**VILLAGE OF ESSEX JUNCTION
PLANNING COMMISSION
DECEMBER 17, 2020
REVISED AGENDA
6:30 P.M.**

A. Final Site Plan review for the removal of buildings #4 and #5 to construct an 8,465 s.f. residential 4 story building with underground parking consisting of 24 1-bedroom units and 20 studio units at 15 Franklin Street in the MCU District by O’Leary-Burke Civil Associates, agents for 222 Franklin Inc., owners.

September 22, 2020

Re: Riverside – 15 Franklin Street
Submittal #1

DATE: 10/9/20	REVISION: REVISED PER VILLAGE ENGINEER COMMENTS	BY: BMC
DRAWN: OLEARY-BURKE	DESIGN: OLEARY-BURKE	CHECKED: OLEARY-BURKE
SCALE: 1"=20'	PROJECT: 15 Franklin St. - Essex Junction, VT	SHEET: 2
Existing Conditions

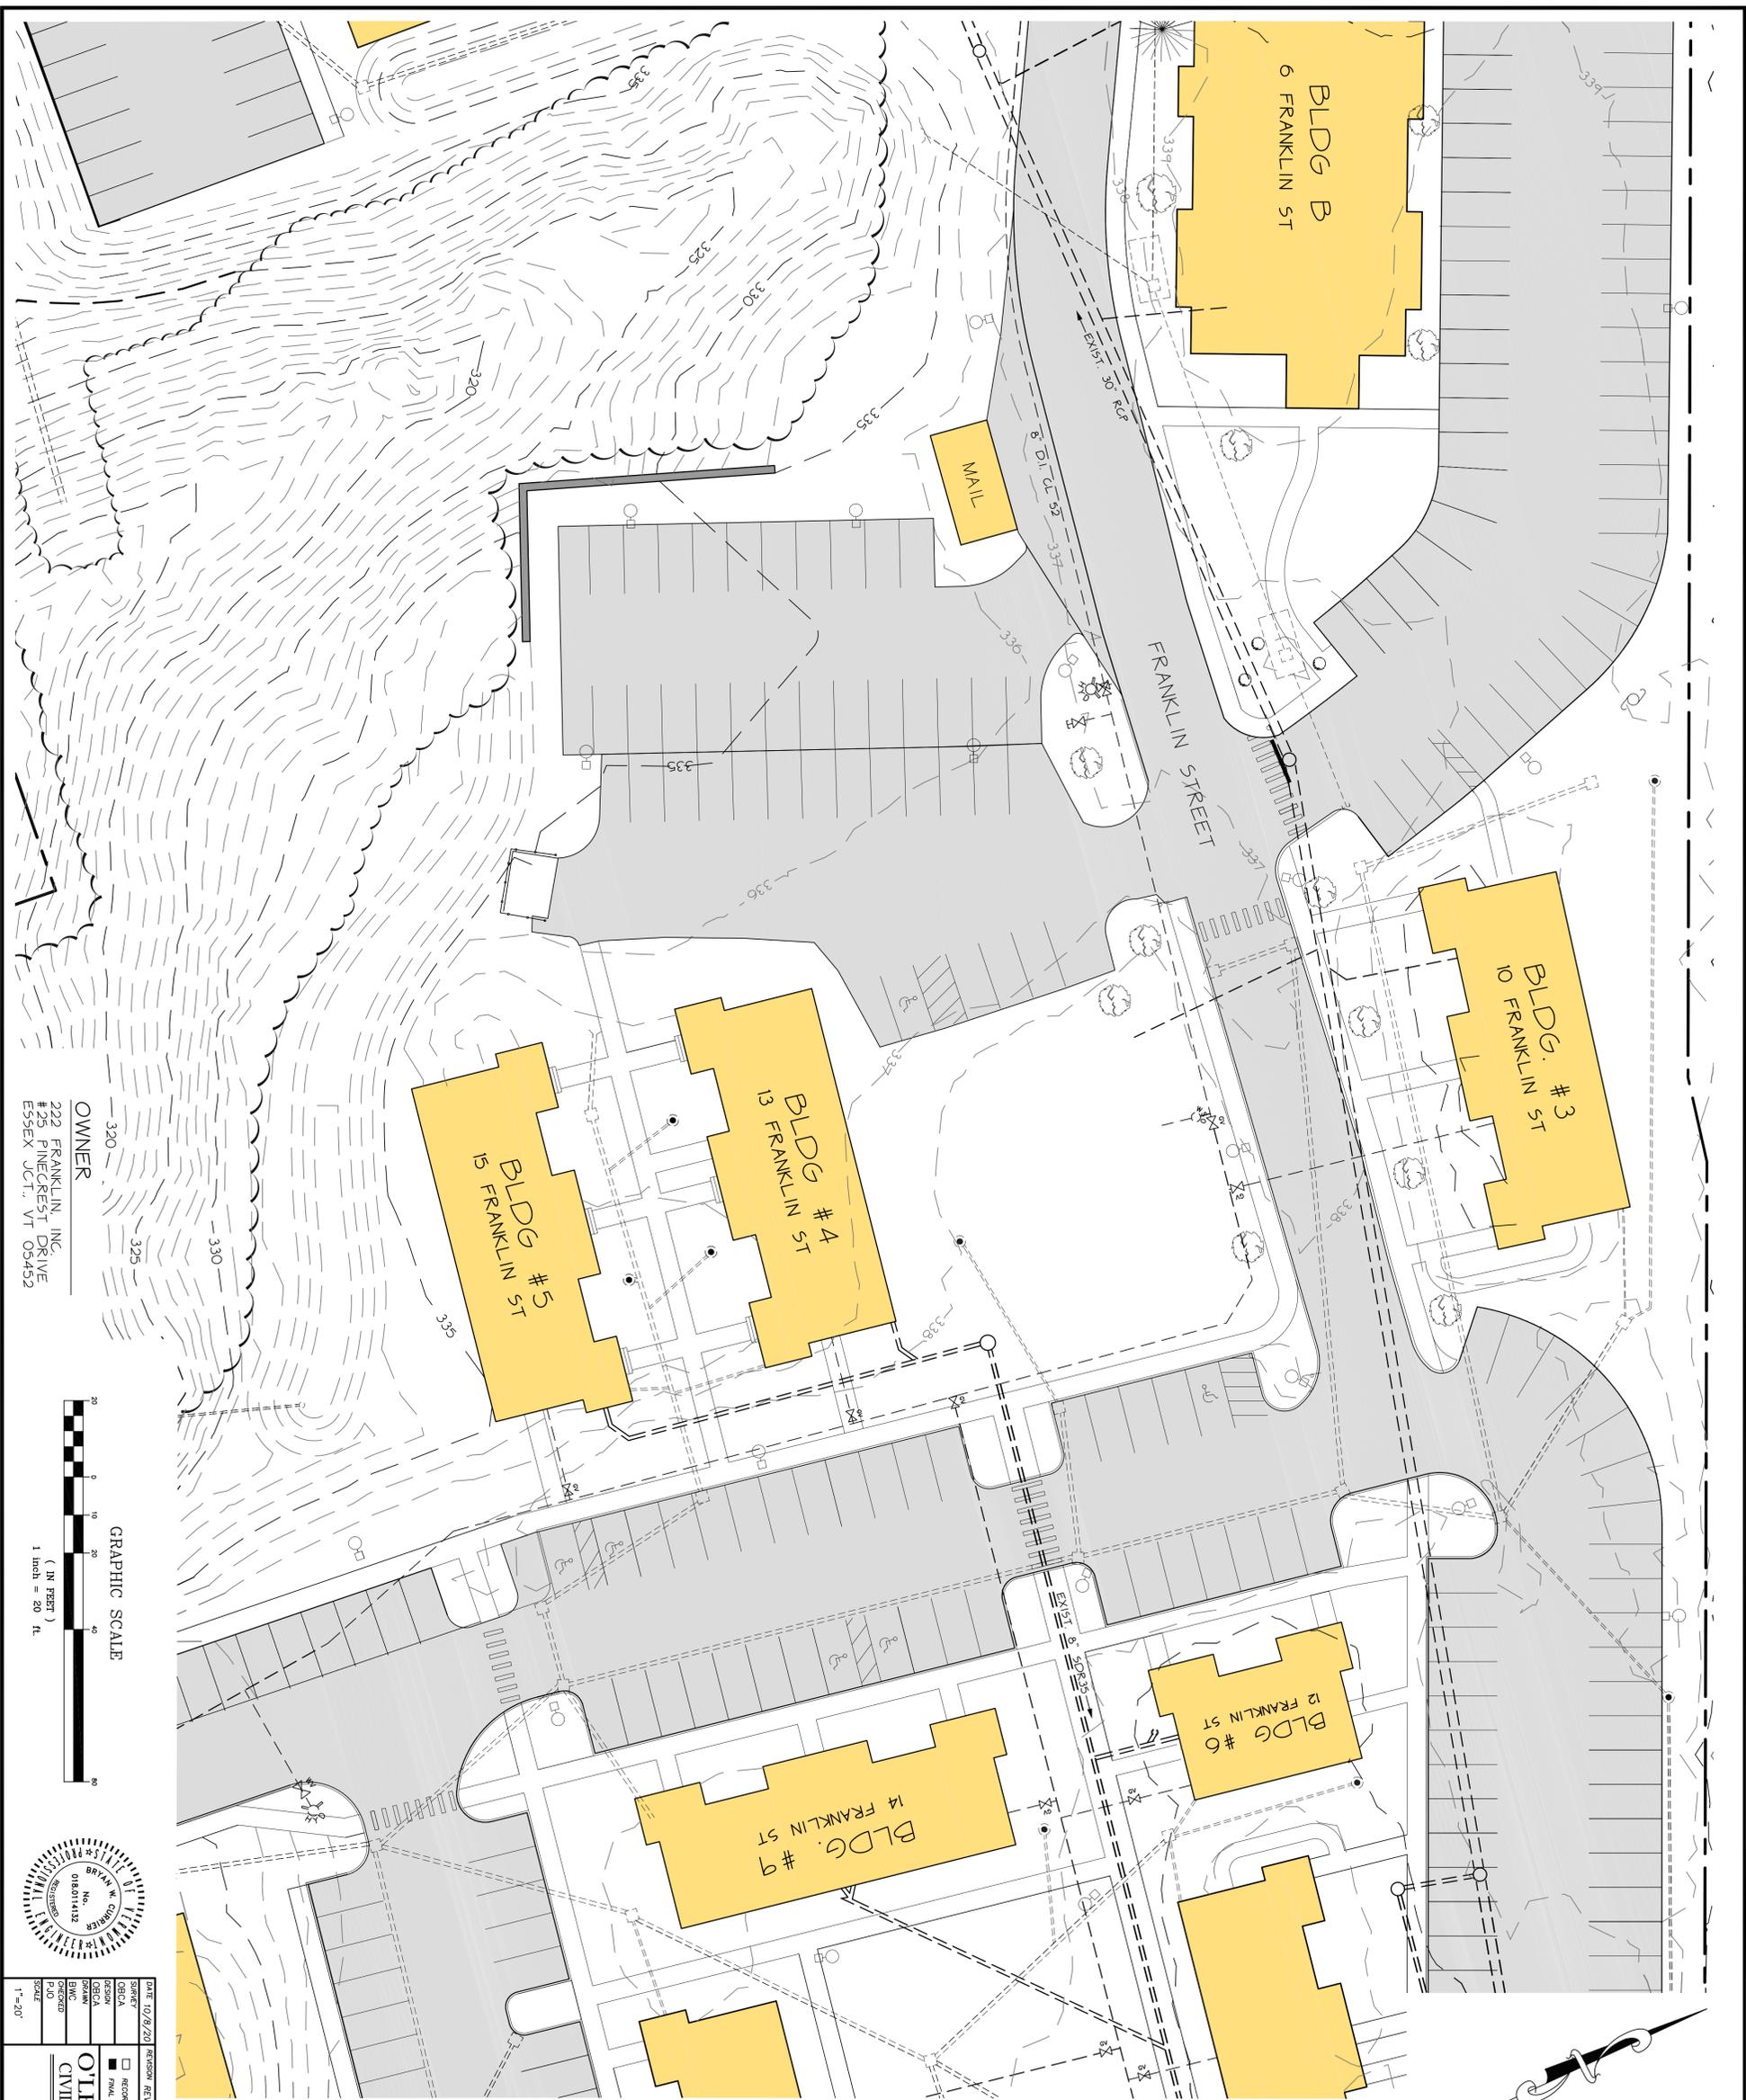
- 2) We recommend a condition of approval of this project requiring the submission of record drawings for site utilities to the Village of Essex Junction upon completion of construction, in both AutoCAD and PDF format. The Village would also like to request this information be provided in shapefile format in Vermont State Plane Meters, NAD83.
- 3) Note #2 on Sheet #5 should be revised to include the telephone number for the Village of Essex Junction Public Works Department (802-878-6942). The DIGSAFE notification notes on Sheet #2 and #3 should also be revised to include this telephone number.

DATE: 10/8/20	REVISION: REVISED PER VILLAGE ENGINEER COMMENTS	BY: BNC
DRAWN: OLEARY-BURKE	DESIGN: OLEARY-BURKE	CHECKED: OLEARY-BURKE
SCALE: 1"=30'	PROJECT: 15 Franklin St. - Essex Junction, VT	SHEET: 3

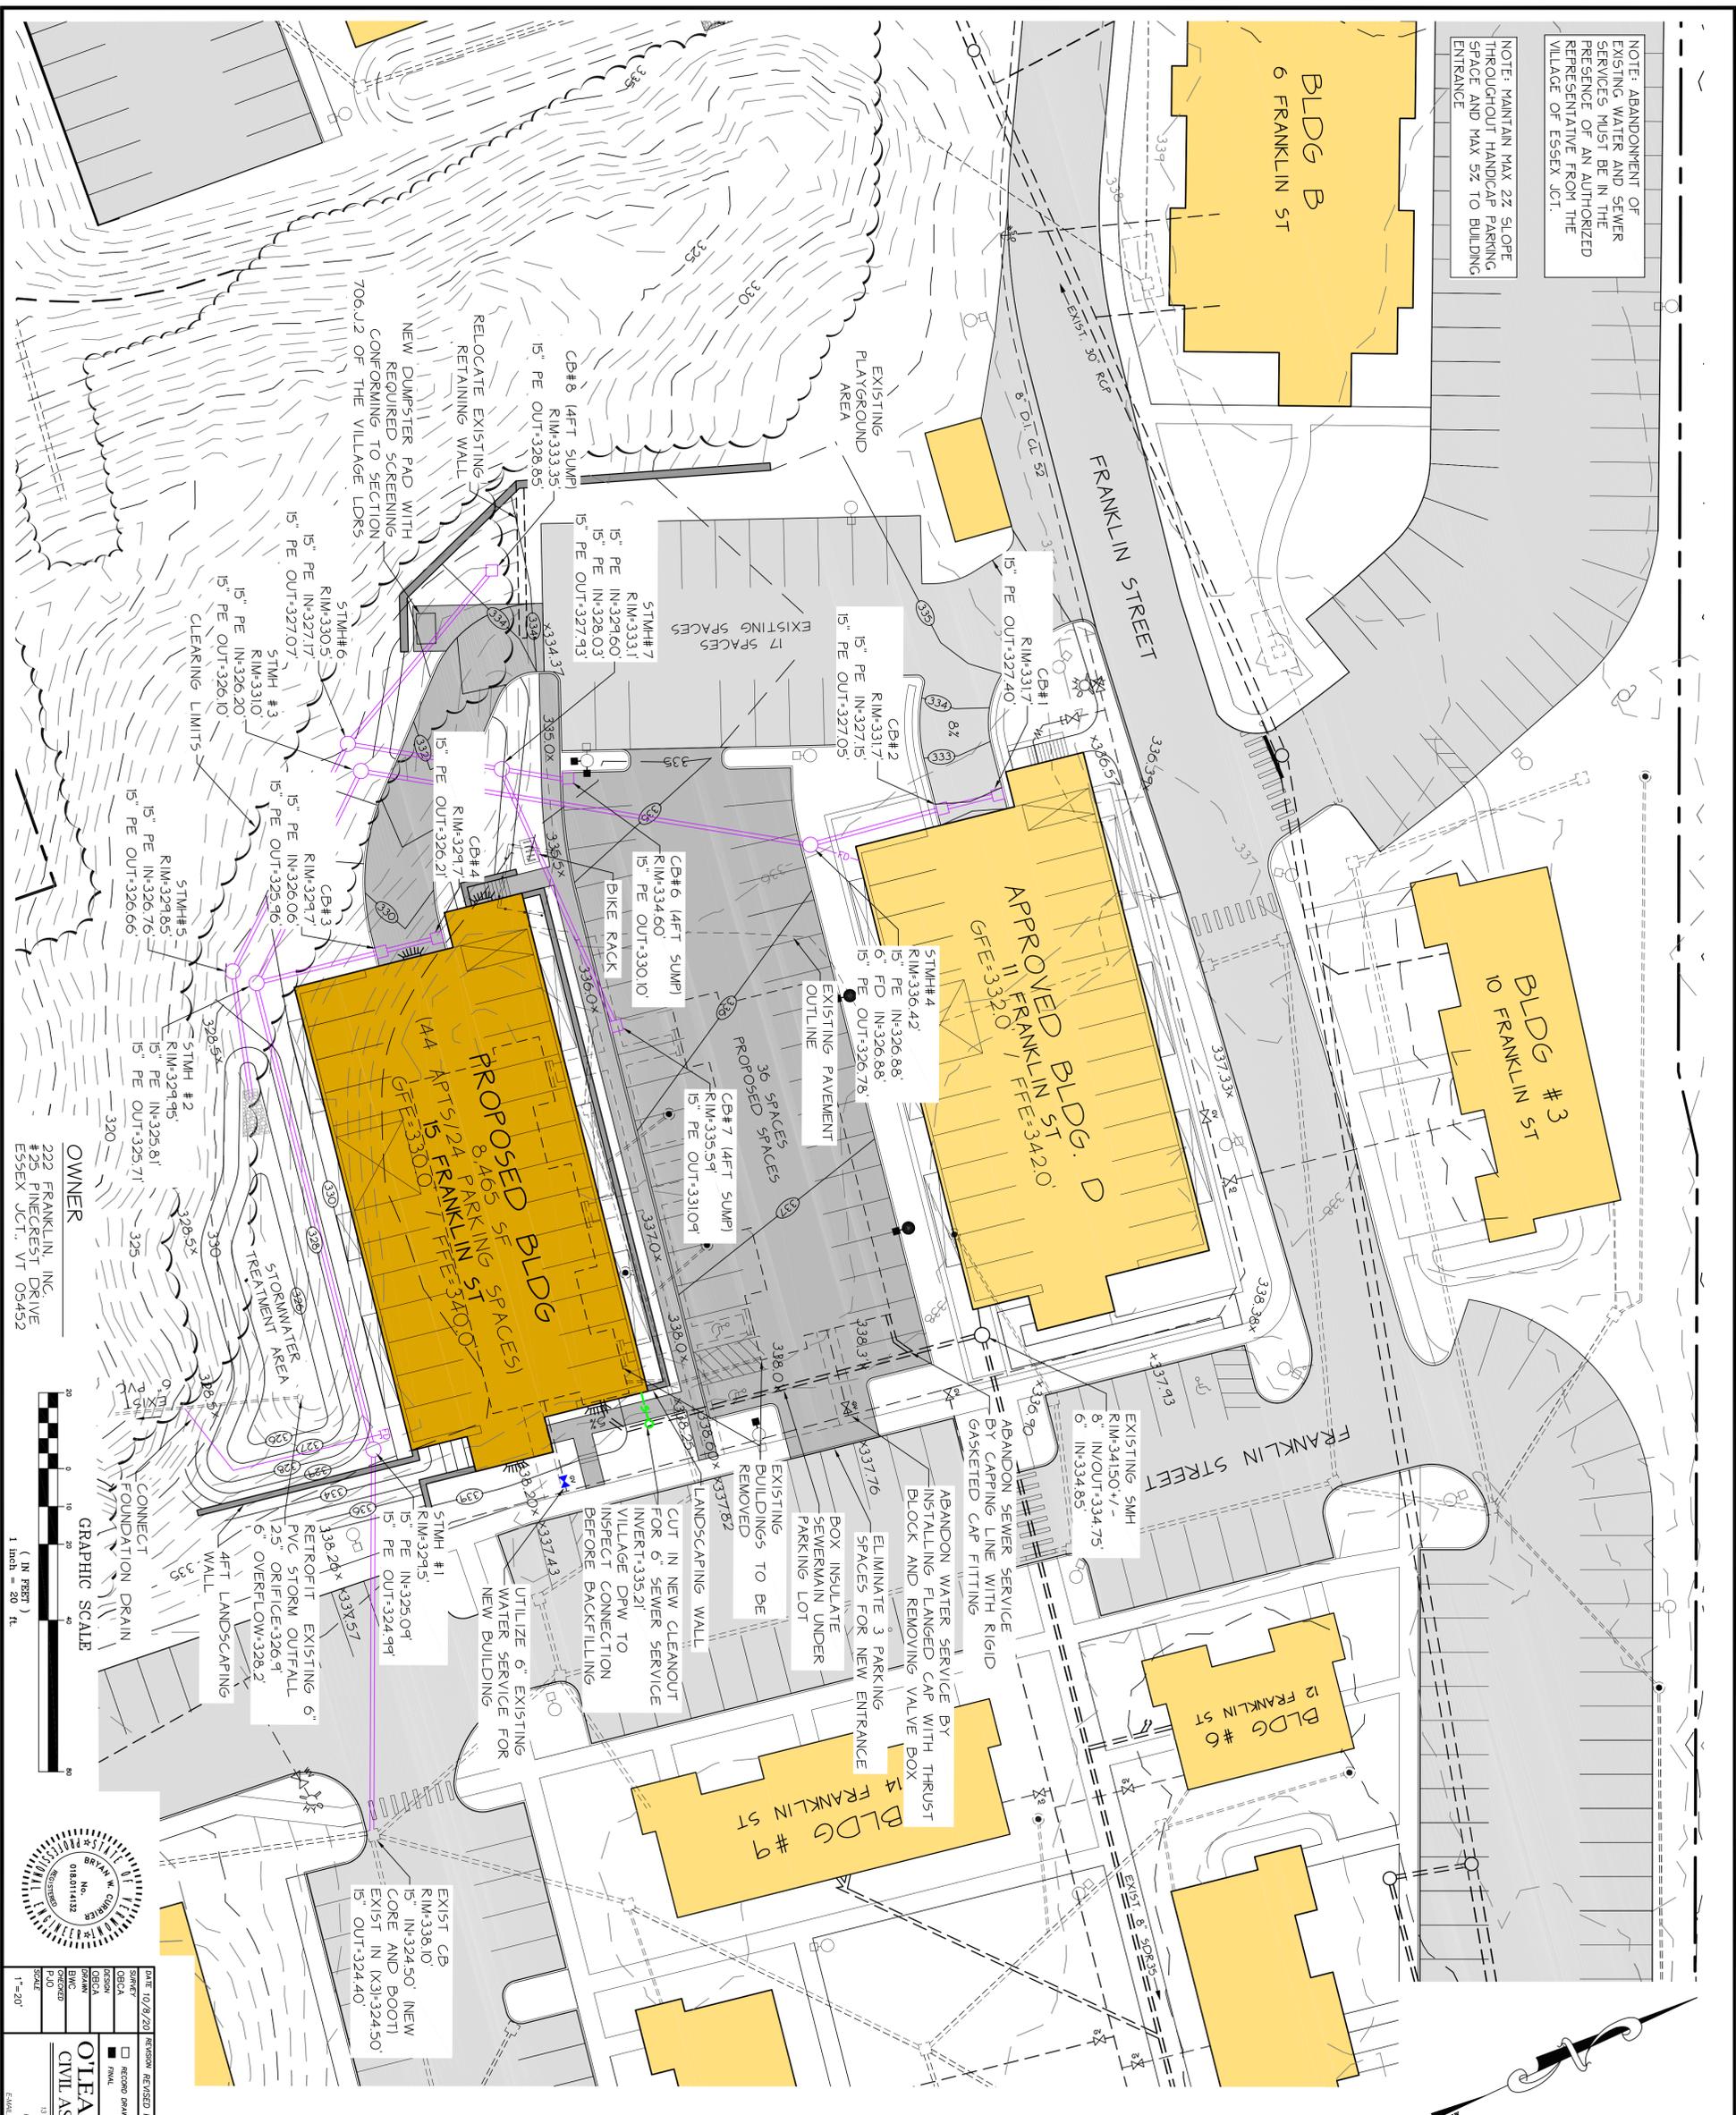
- 3) We recommend that the plans be revised to provide at least two accessible parking spaces in the new parking area; located in the vicinity of the new walkway leading to the front entrance of the proposed building.

- 1) Sheet #3 calls for the installation of a new cleanout for the new 6" sewer service for the new building in the existing sewer service line serving the existing building #4 that is to be removed. The plans should be

revised to require the abandonment of the existing sewer service serving the existing building #4 using a rigid, gasketed cap fitting.

- 2) The plans should be revised to require that the connection of the new building sewer to the existing sewer piping be inspected by an authorized representative of the Village of Essex Junction prior to backfilling.
- 3) The applicant should provide confirmation that adequate capacity exists in the existing sewer pump station to accommodate the increased flow anticipated as a result of this project.
